# DC SHPO UNDERTAKING REVIEW REQUEST (URR)

## URR #34: GOLF HOLE RELOCATION AND BALL FIELD RESTORATION

**DC STATE HISTORIC PRESERVATION OFFICE**  
**SECTION 106 REVIEW FORM**

**PROJECT NAME/DESCRIPTION:** Armed Forces Retirement Home, URR 34 (Golf Course Relocation)

**CLEARING PLAN**  
LANDSCAPE

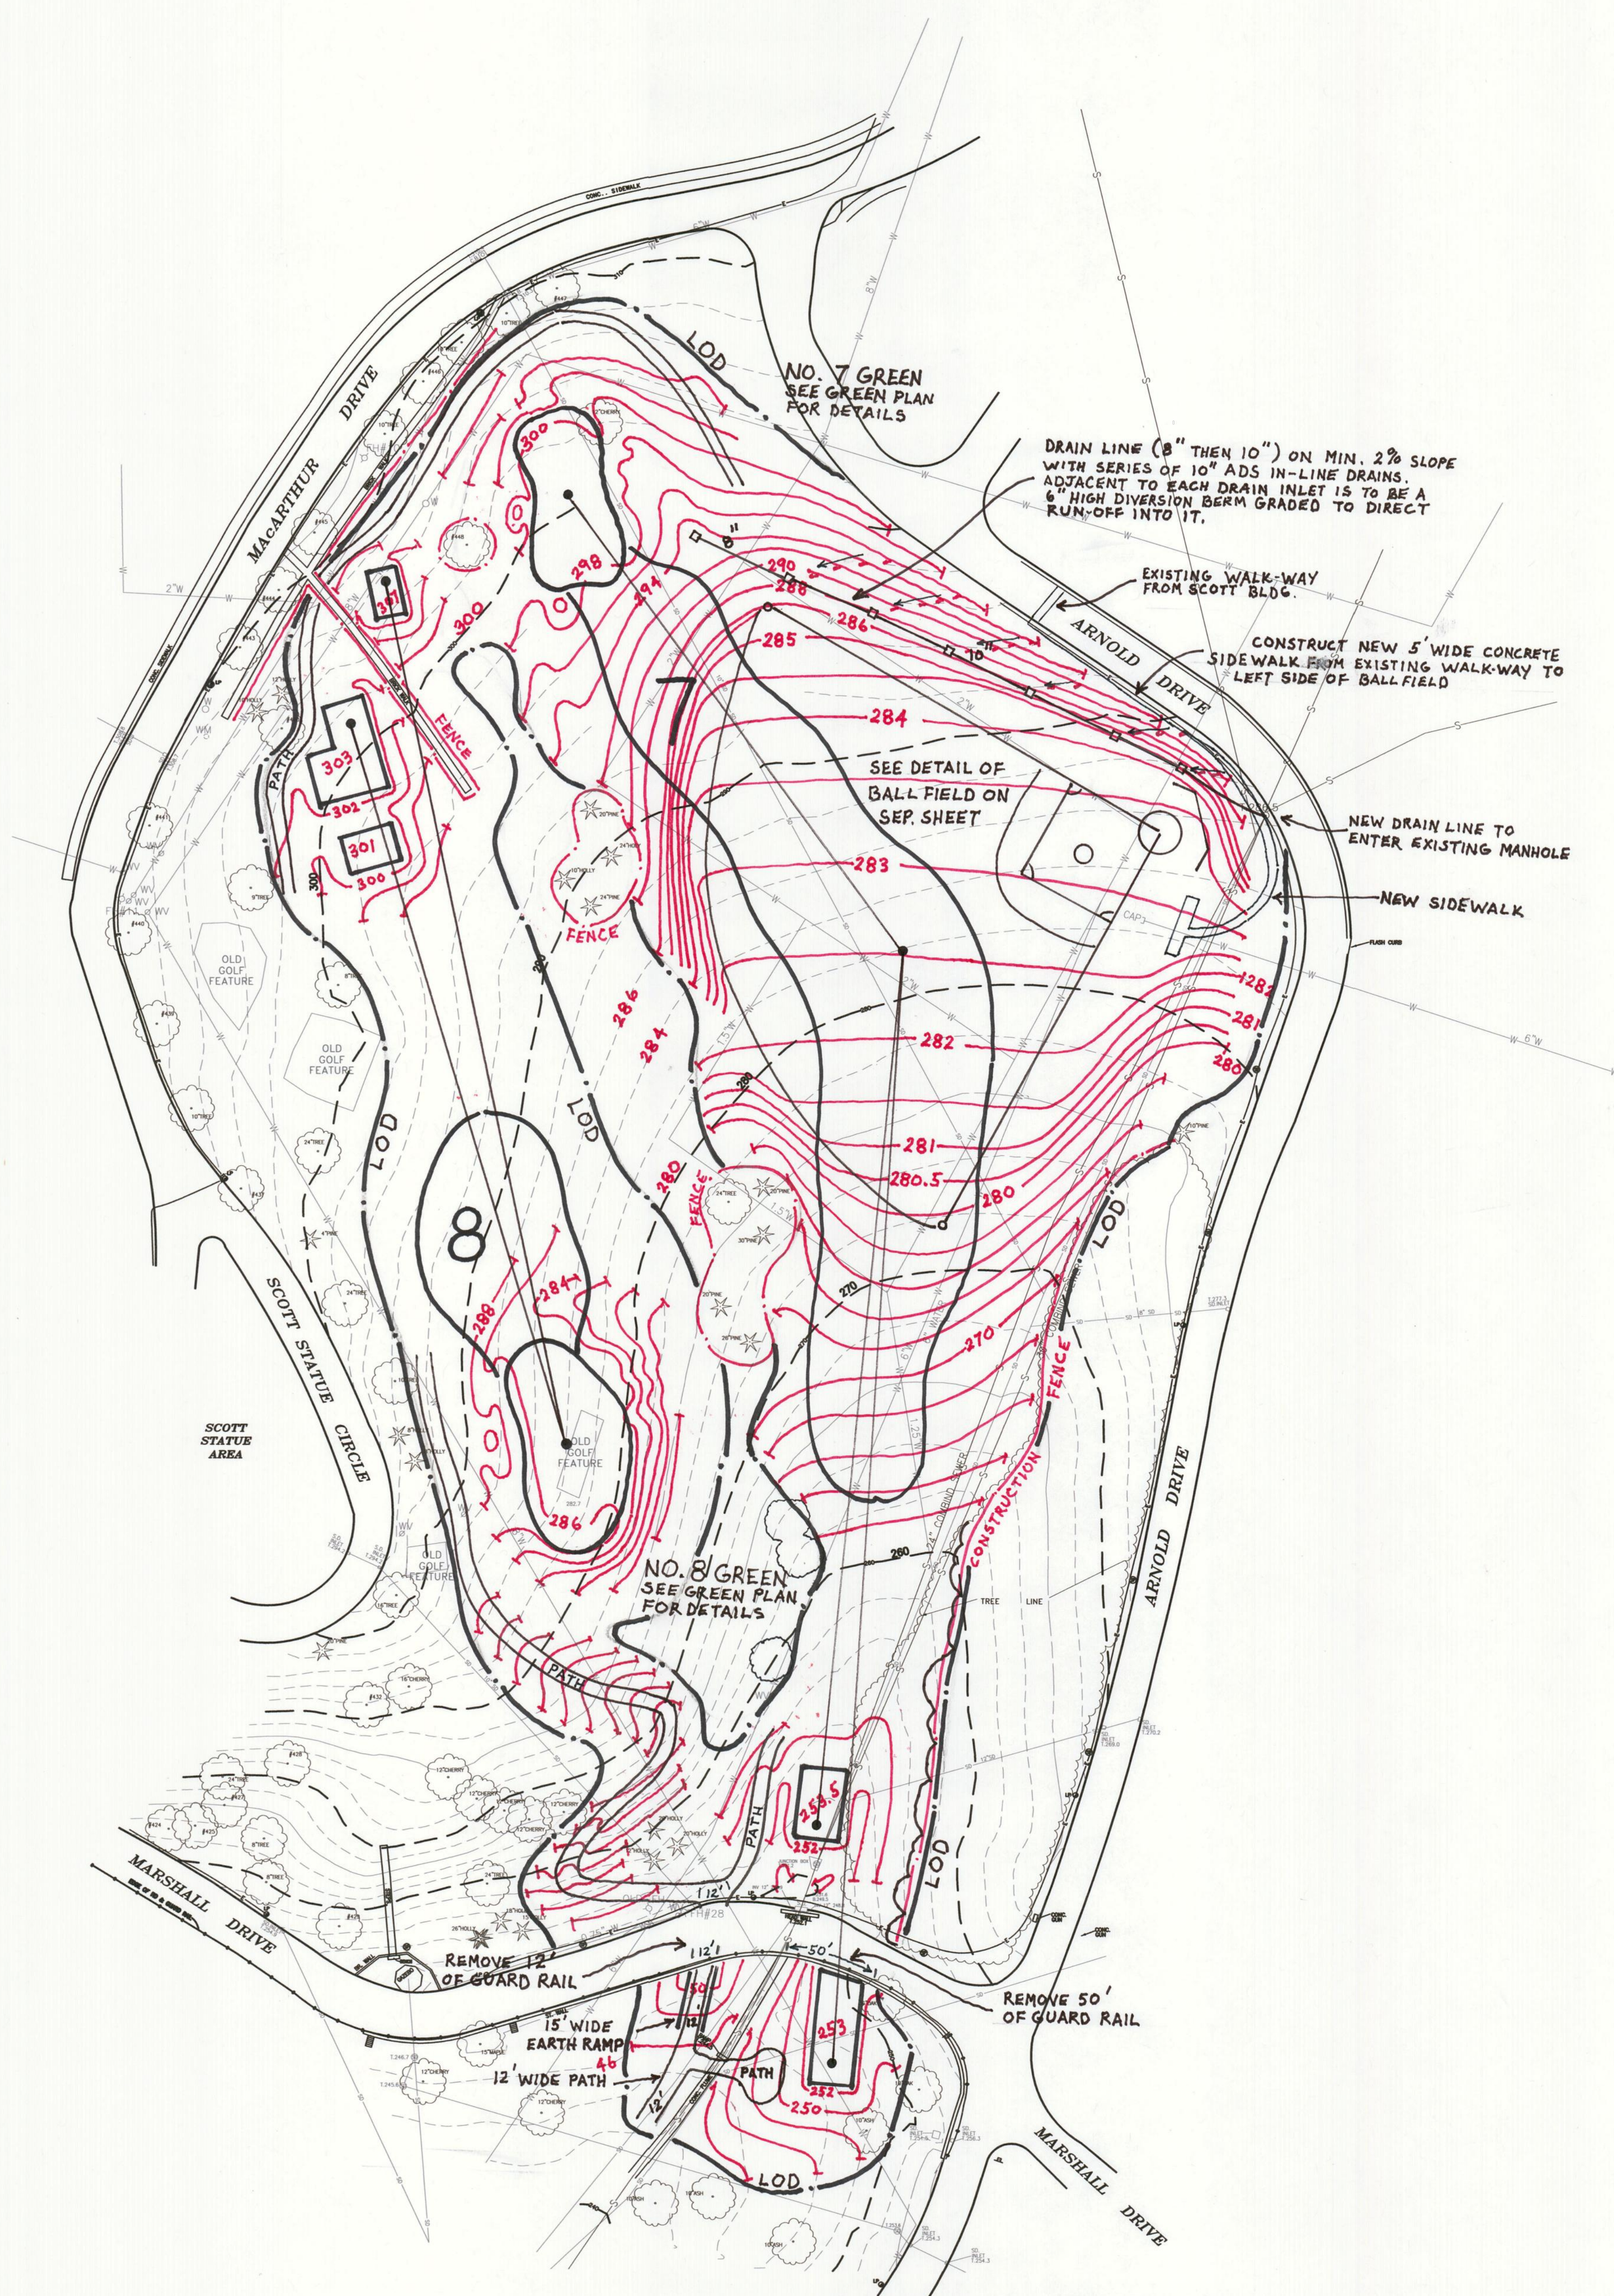
1. trees will be planted within the portion of Chapel Woods west of Arnold Drive, so that there is no net loss of area of the woods;
2. removed trees will be replaced on a one-to-one basis consistent with the master plan and associated documents; and
3. AFRH will establish a habitat conservation zone in the woods,

there will be no adverse effect from the removal of some trees at the southwest corner of the woods for the creation of new golf holes and fairways.

Yes, I guess I disagree. I don't think the analogy with a building is fully applicable because a wood is a living thing, and few of the trees probably go back to the founding of the institution; they replace themselves. The extent of the woods is important; if it gets too thin, I think it really loses its character. And I don't see why the treatment of a landscape consisting of trees would be lesser than that for individual or copses of trees that are not considered particularly important.

- (2) **Replace removed mature trees on a 1-1 basis, and use replacement trees to replenish areas of the woodland that have been affected by previous disturbance.** The area of Chapel Woods West located west of Arnold Drive has substantially decreased since the period of significance of the AFRH-W Historic District. Most of this reduction is due to the substantial disturbance of the area in the 1950s, during the construction of the previous Scott Building, the realignment of Arnold Road, and the burying of the streambed that ran north-south through the Meadow. To ensure zero net loss of woodland area, AFRH will replace all removed mature trees on a 1-1 basis (as required by the Programmatic Agreement), and locate those trees within the area of Chapel Woods West that was

depleted by these previous undertakings (see Attachment C). Mature trees will be defined as a tree with a 3" caliper, as measured from 24" above the ground. Replacement trees will follow all guidelines set forth in the Historic Preservation Plan and Master Plan, including:
